# Wollongong Local Planning Panel Assessment Report | 10 December 2020

<b>WLPP No.</b>	Item No. 2
<b>DA No.</b>	DA-2020/460
<b>Proposal</b>	Construction of mixed use development consisting of two (2) storey shop top housing building consisting of three (3) commercial tenancies and two (2) residential units and three (3) storey residential flat building consisting of six (6) residential units and one (1) level of basement car parking
<b>Property</b>	164-166 Balgownie Road, Balgownie and 22 Church Street, Balgownie
<b>Applicant</b>	PRD Architects
<b>Responsible Team</b>	Development Assessment & Certification – City Centre (NM)
<b>Development cost</b>	\$4,175,000
<b>Lodgement date</b>	18 May 2020
<b>Prior WLPP meeting</b>	N/A

## ASSESSMENT REPORT AND RECOMMENDATION

BALGOWNIE ROAD PUBLIC DOMAIN WORKS  
1:50@A1

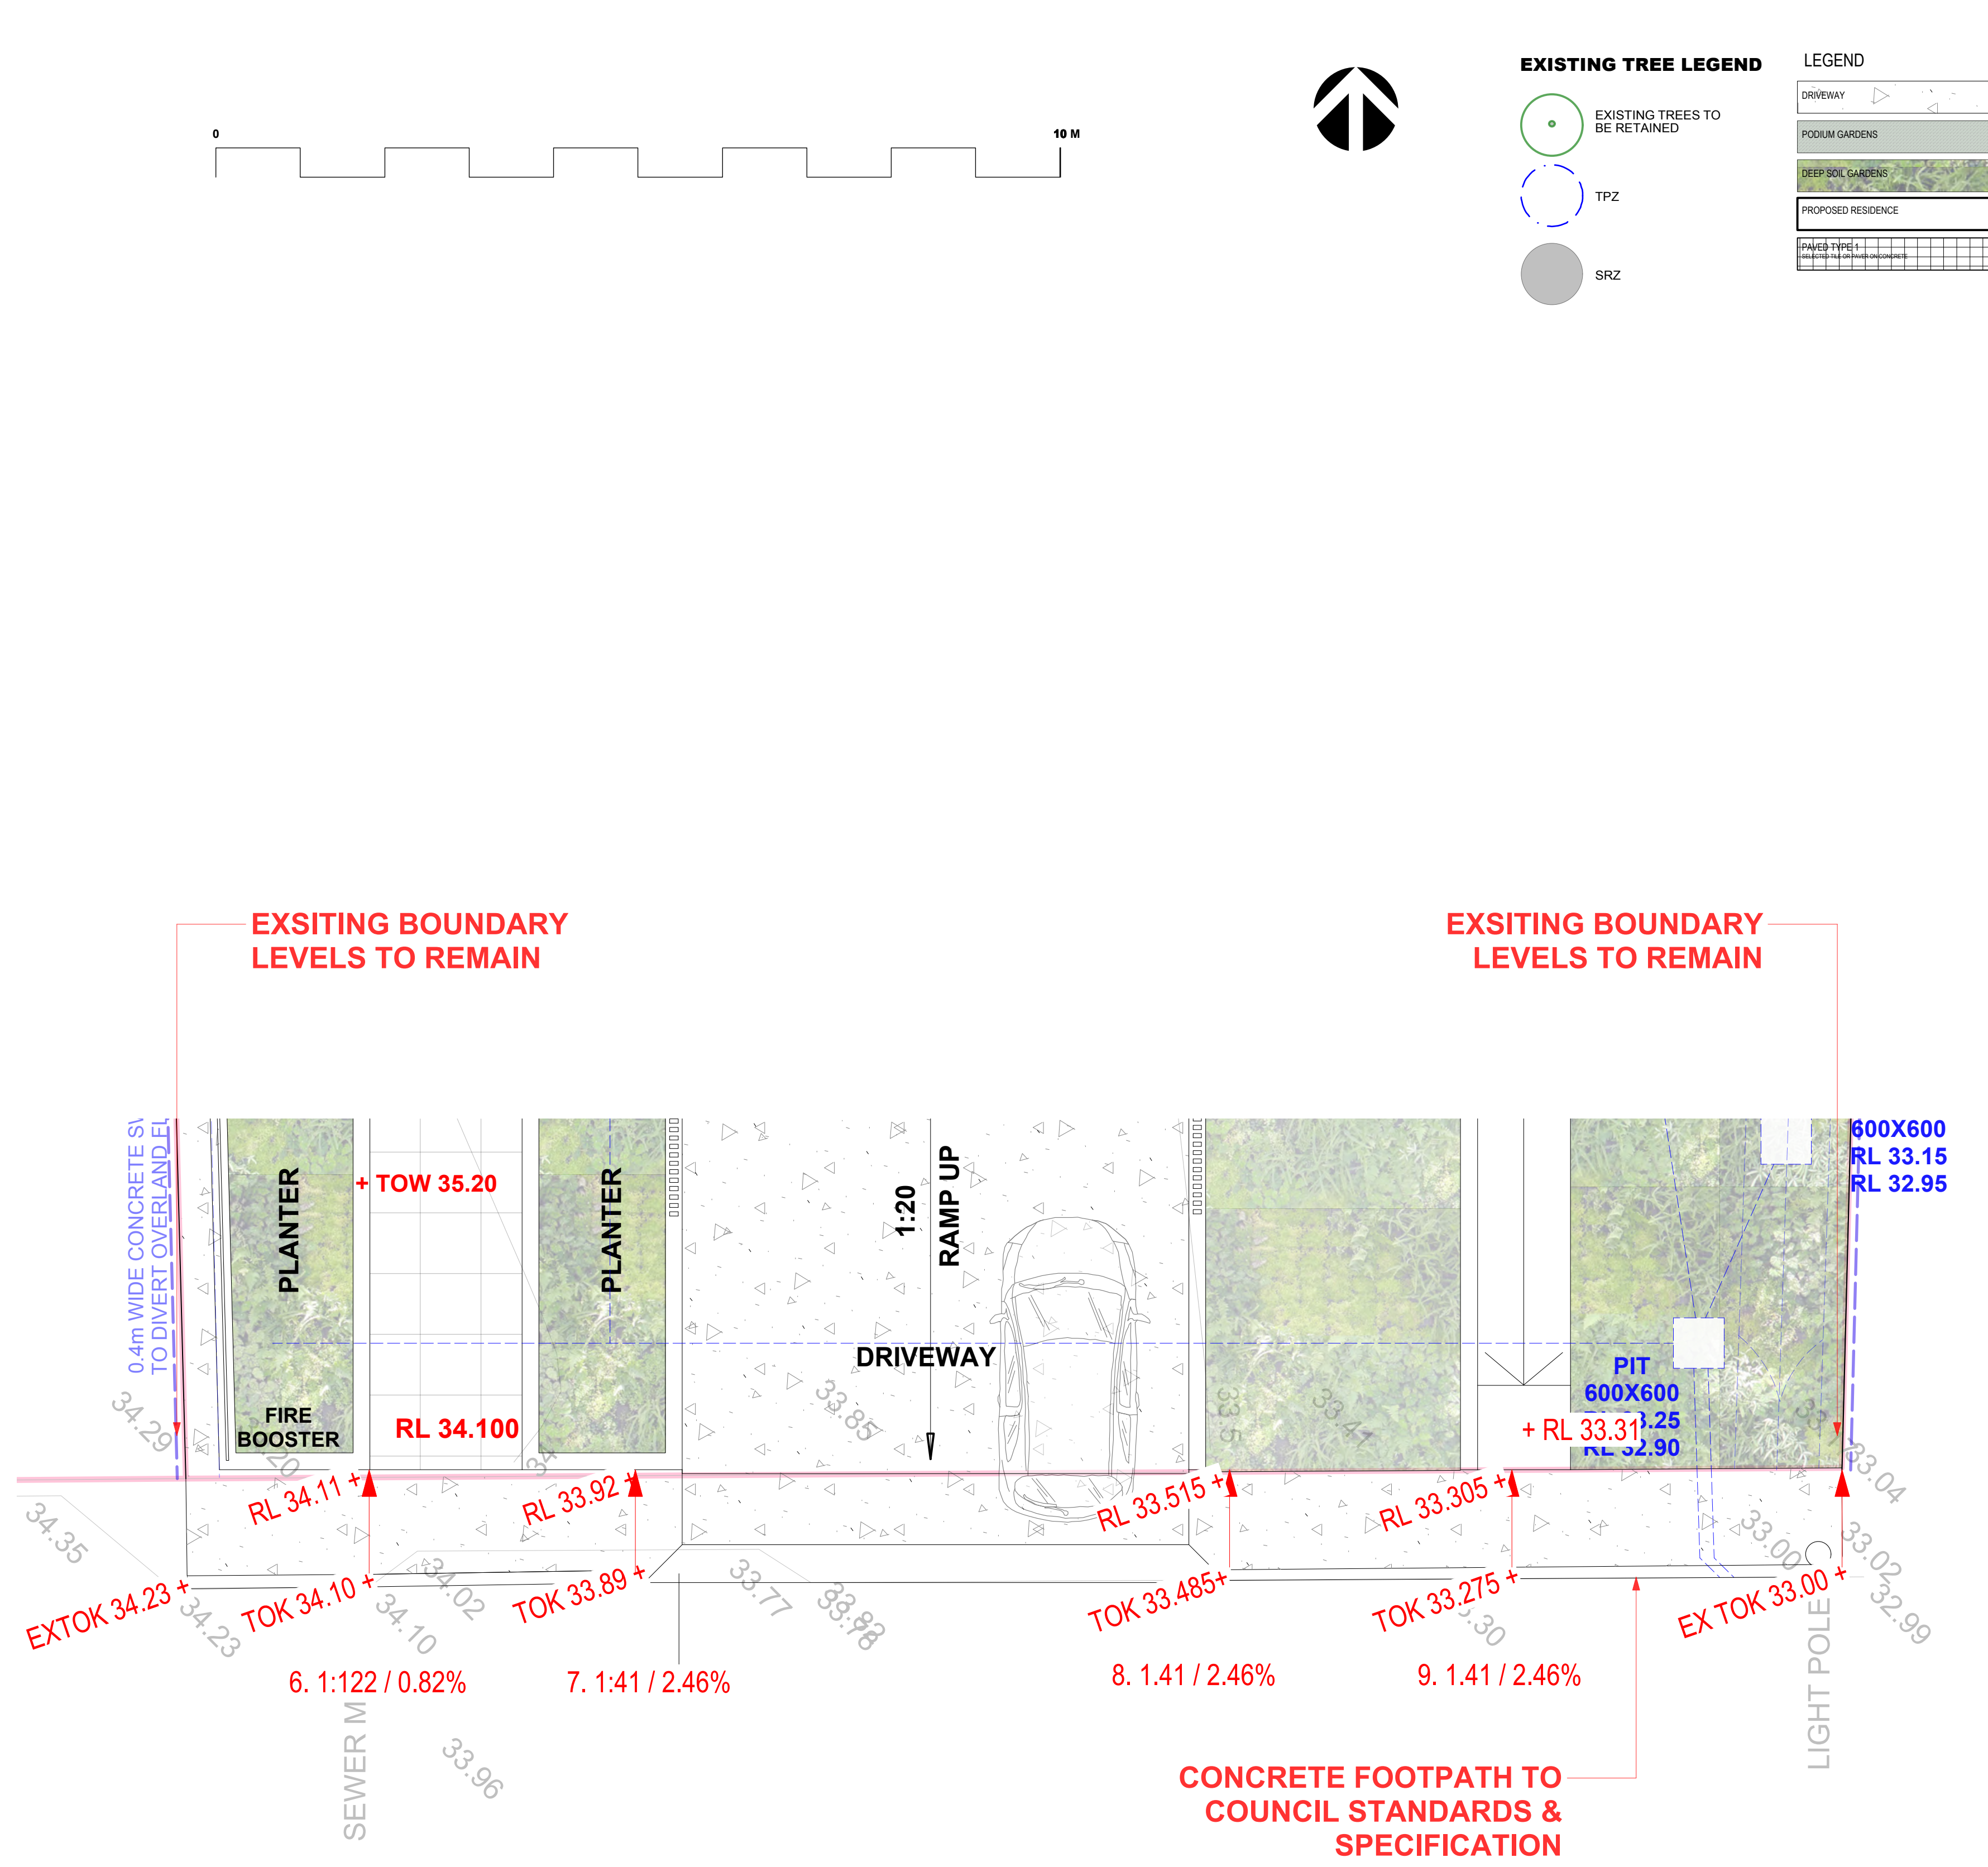
The developer is responsible for the construction of footpath paving for the entire Balgownie Road frontage of the development. In keeping with the surrounding commercial precinct and the Business Centres Public Domain Technical Manual, the design of the public domain to Balgownie Road identified on the Landscape Plan by Site Design + Studio sheet L-06 J dated 5 November 2020 is to be amended to include feature brick banding at approximately 8m centres.
